Subject: Installation Restoration Site 1: Analysis of Trenching Study and Deficiencies in Proposed Plan

Analysis of Trenching Report

Deficiencies in the Proposed Plan

Figure 1-1
TRENCH LOCATIONS

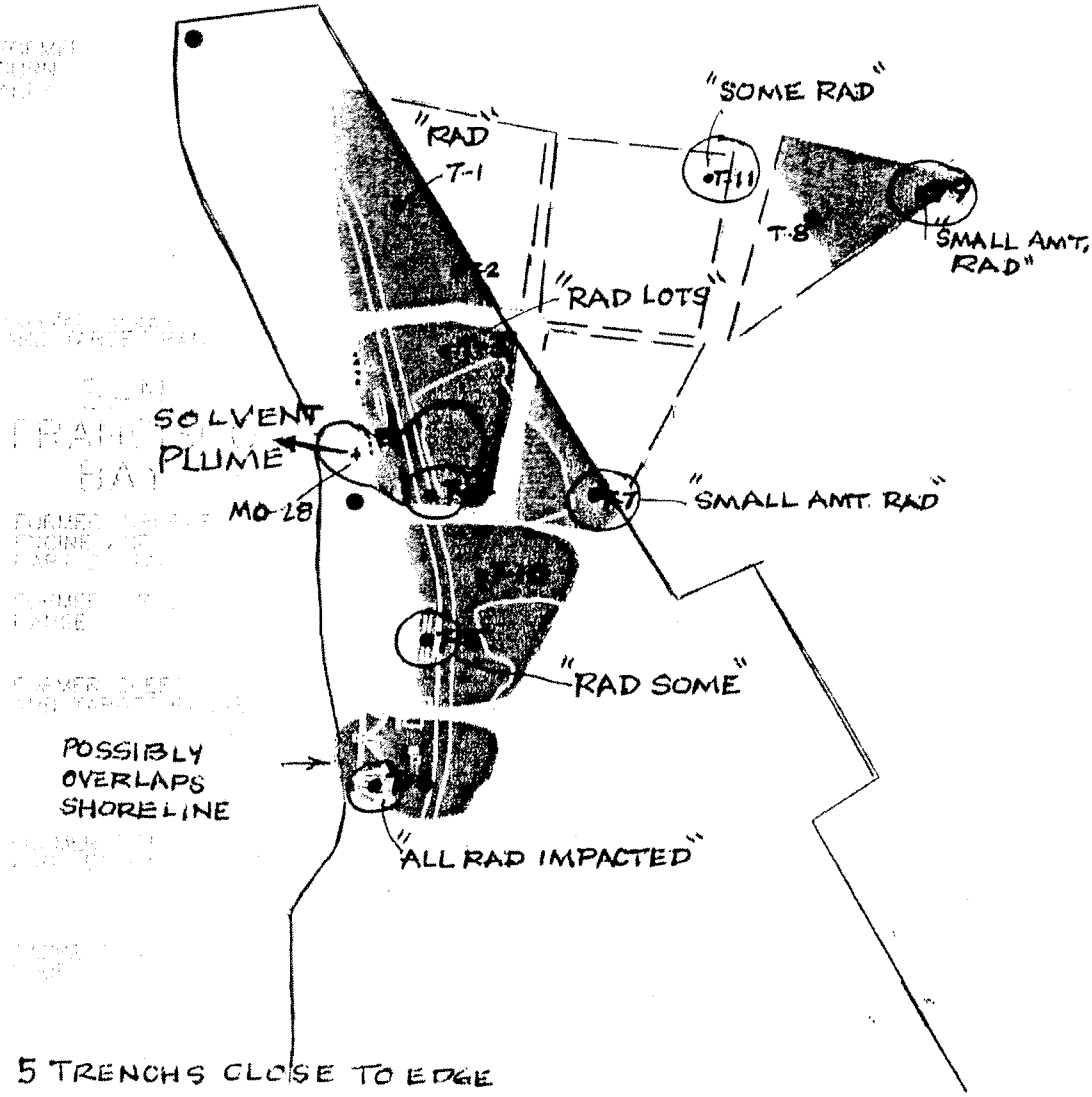
Figure 1-1 from the trenching report is attached and has been annotated by the writer. Note that five of the trenches were located relatively close to the walls separating the waste cells. These locations have been circled in the figure. If the locations of these trenches were off only slightly, the trenches may have been cut into the walls between the cells or into the sloping portions of the walls. Thus, it would not be surprising if little or no waste debris were found.

Of the eleven trenches, seven showed some excessive radioactive contamination (as indicated on the trenching logs for the respective trenches). Perhaps more significantly, six of the seven cells had some radioactively contaminated soil in the excavated soil.

Another observation from Figure 1-1 is that the southernmost cell (in which trench T-6 was excavated) overlaps or abuts the shoreline. This indicates that either wastes from this cell are currently exposed to the Bay or that they could easily be exposed by minor shoreline erosion in the future. Note also the notation from the T-6 trench log that all the excavated soil from this cell was radioactively impacted. One would expect some radioactive contamination of the adjacent beach area.

5 TRENCHS CLOSE TO EDGE
OF 11 TRENCHS
7 HAD SOME RAD CONTAMINATION
4 W/O RAD CONTAMINATION
OF 7 CELLS,
6 HAD SOME RAD CONTAMINATION
225 CY TOTAL VOLUME EXCAVATED (PG. 3)
57 CY RAD-IMPACTED SOIL (> 6000 CPM)

Current Areas of IR Sites

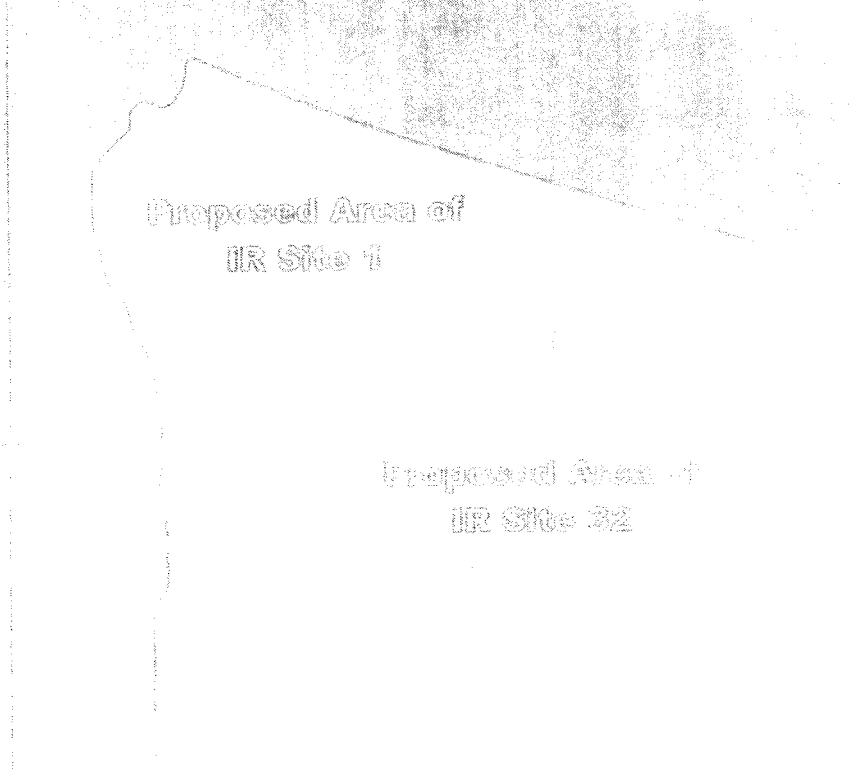
The Navy outlined a proposal to modify the closure strategy for Installation Restoration (IR) Site 1 at the April 15, 2008 and June 17, 2008 BRAC Cleanup Team (BCT) meetings. The proposed change in strategy is based upon the latest findings of the Sites 1, 2, and 32 Time-Critical Removal Action (TCRA) conducted from February 2007 through the present. The findings of the TCRA affect the Conceptual Site Models and the closure strategies for adjacent Sites 1 and 32 and for the area located east of Site 1 and south of Site 32. This letter proposes a change of closure strategy for these areas.

- Includes Areas 1a, 1b, 2b, 4, 5a, 5b, and groundwater.
- The existing Site 1 Draft ROD will be used as a basis to issue a Draft-Final ROD describing the change in strategy and deletion of Areas 2a, 3a, and 3b from Site 1.
- No changes are proposed for the selected remedies in the remaining areas.
- During the planning stages of remedial action for Site 1, the Navy will conduct a radiological survey to determine the lateral extent of radium-226 at Site 32.

- Includes soil at Site 1 Areas 2a, 3a and 3b, soil and groundwater at Site 32, and soil located east of Site 1 and south of Site 32 in an area yet to be determined.
- An RI/FS addendum that includes findings from the TCRA and explains the addition of Site 1 areas and the expanded soil areas.
- A Site 32 Proposed Plan and ROD will be issued after BCT concurrence with the FS amendment.
